February 26, 2014
L-2014-041

Re: Turkey Point Unit 3 and Unit 4
Docket Nos. 50-250 and 50-251
Florida Power and Light Company's Turkey Point Units 3 and 4, Second Six-Month Status Report in Response to March 12, 2012, Commission Order Modifying Licenses with Regard to Requirements for Mitigation Strategies for Beyond-Design-Basis External Events (Order Number EA-12-049)

Second Six Month Status Report for the Implementation of Order EA-12-049

4 Changes to Compliance Method

OIP Attachment 4
Conceptual Sketches and Modifications
Modification No. 7 (Unit 3 Shown, Unit 4 similar)

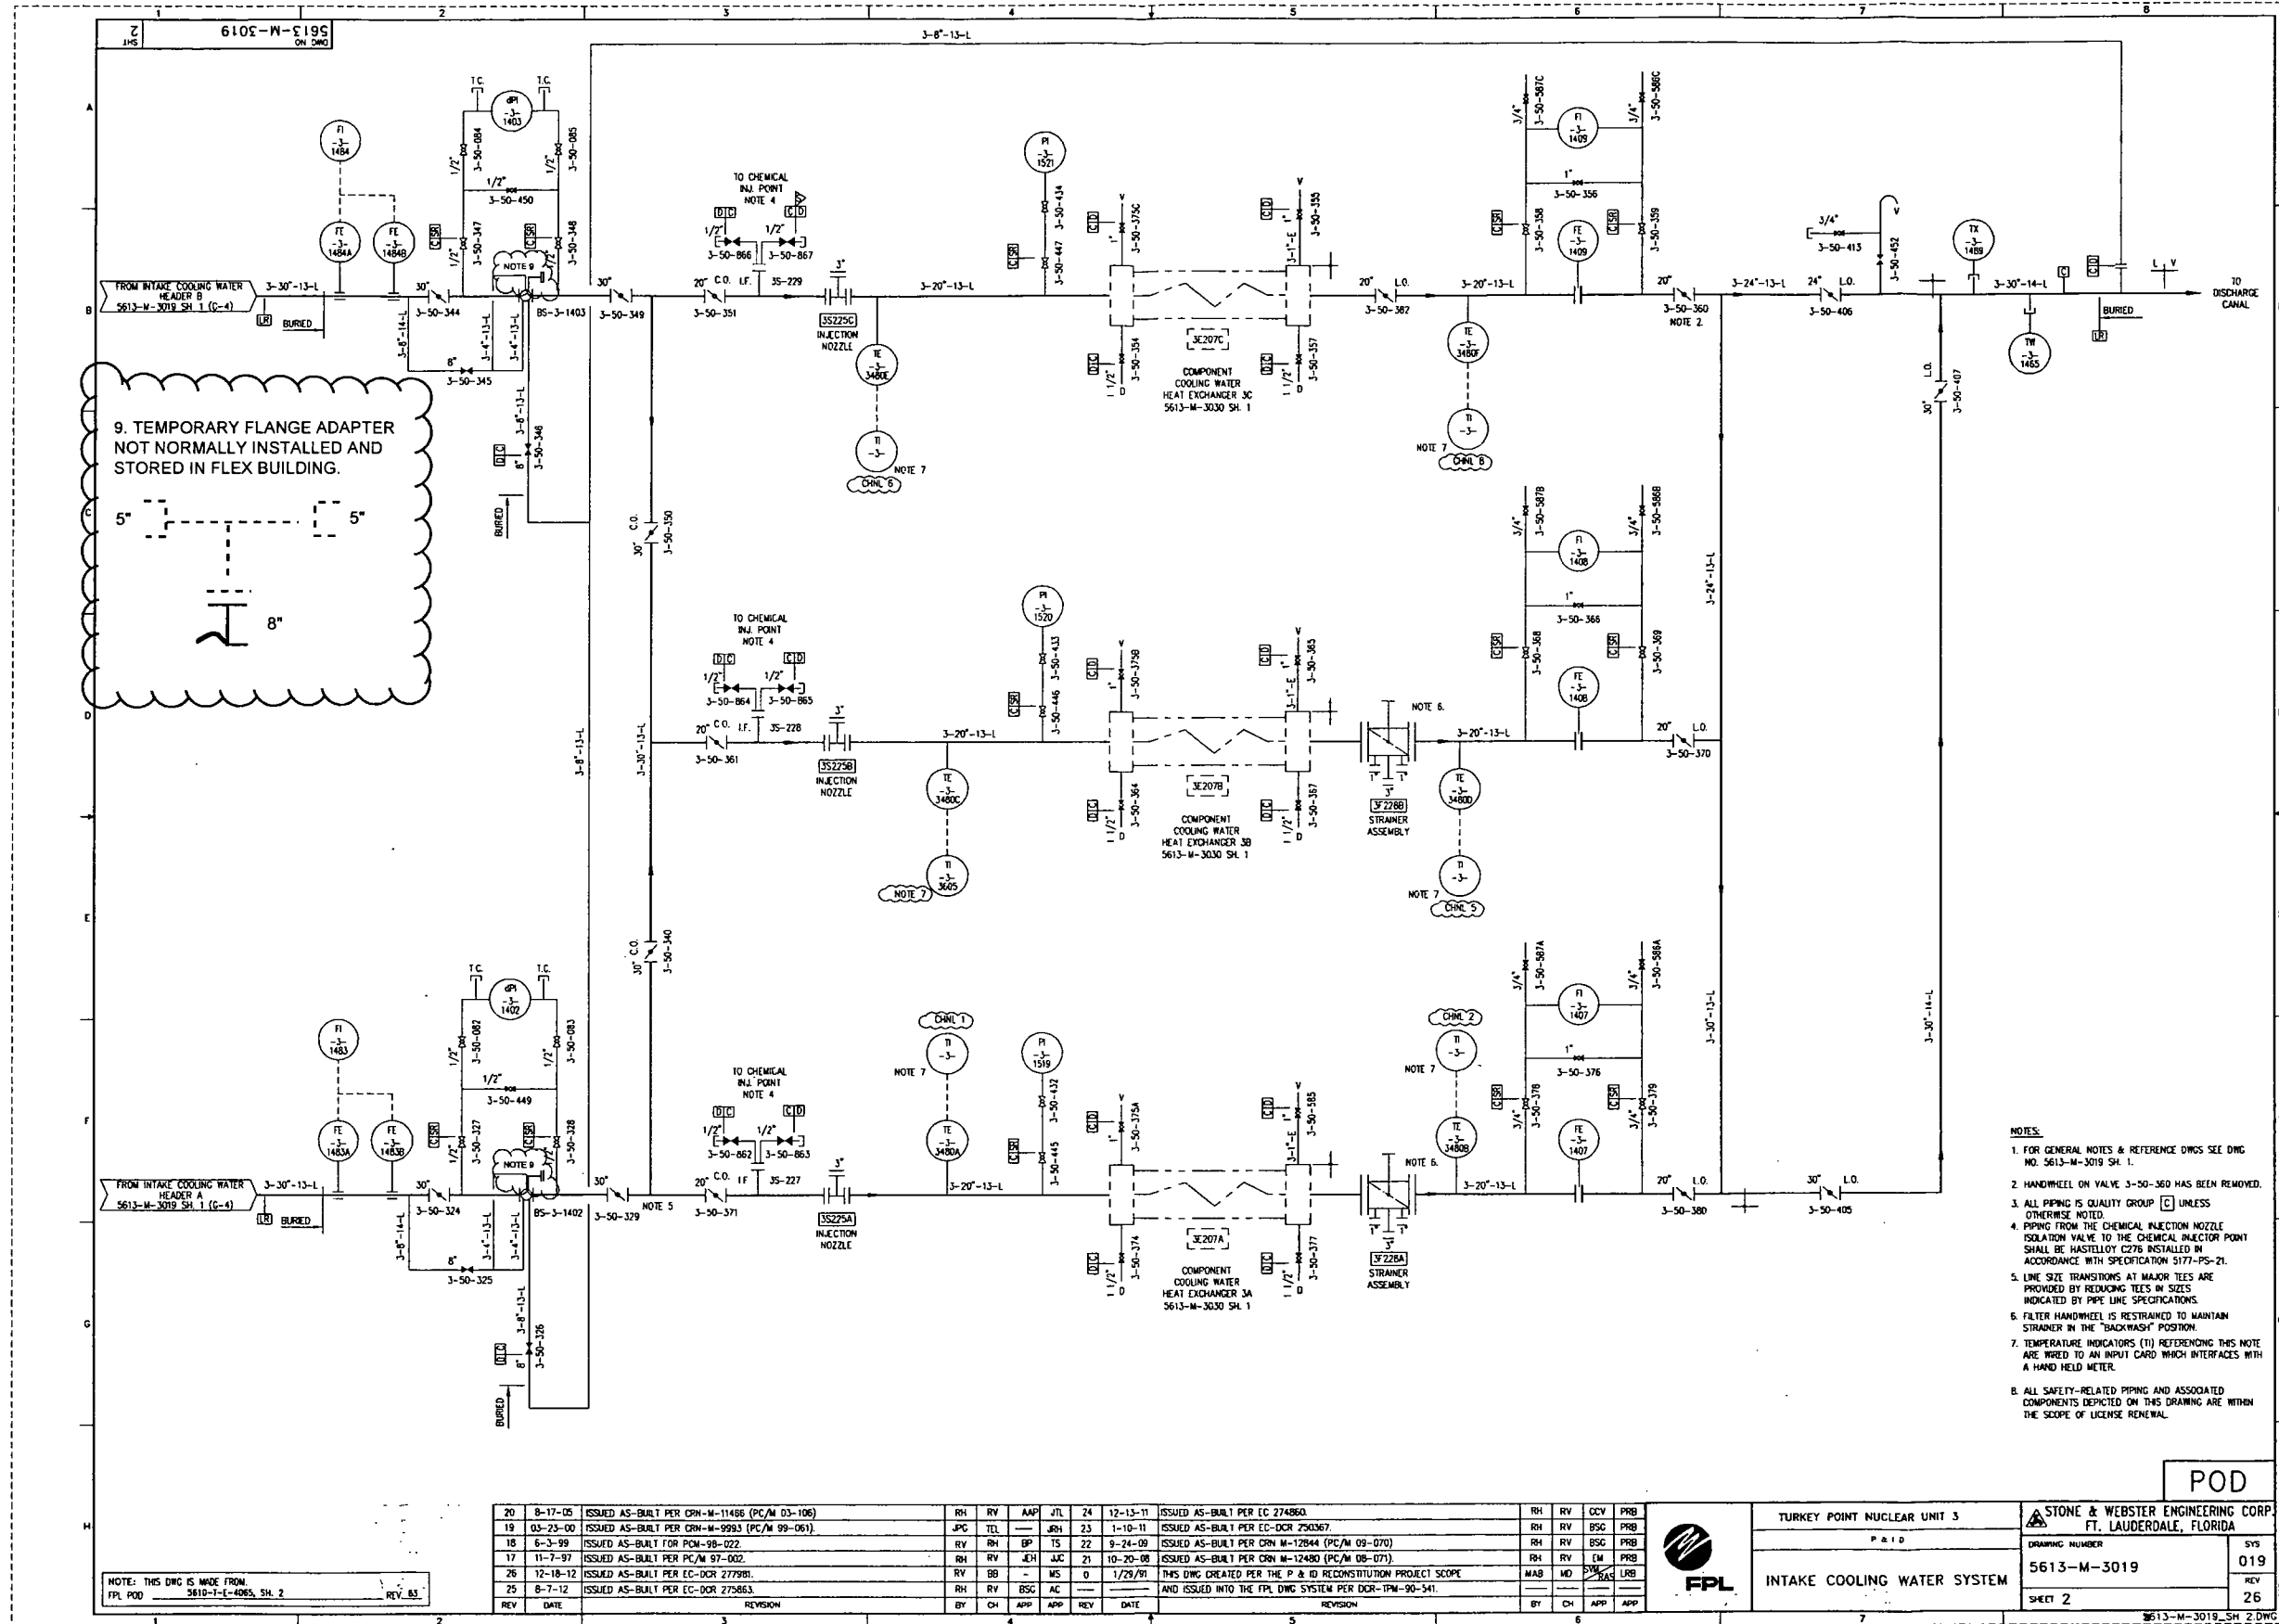
Modification No.7 Install hose connection to Intake Cooling Water line

The previous 6 month update report (Reference 3) included a sketch showing two new hose connection points to the Intake Cooling Water (ICW) strainers along with a temporary hose adapter to supply both CCW heat exchangers during Phase 3. After more detailed design efforts, the temporary adapter will be provided with two hose connection instead of one to ensure adequate flow capacity. A revised modification No. 7 conceptual sketch has been provided in Attachment 4. This change will not affect the strategy or ability to maintain core cooling and heat removal by equipment credited during Phase 3.
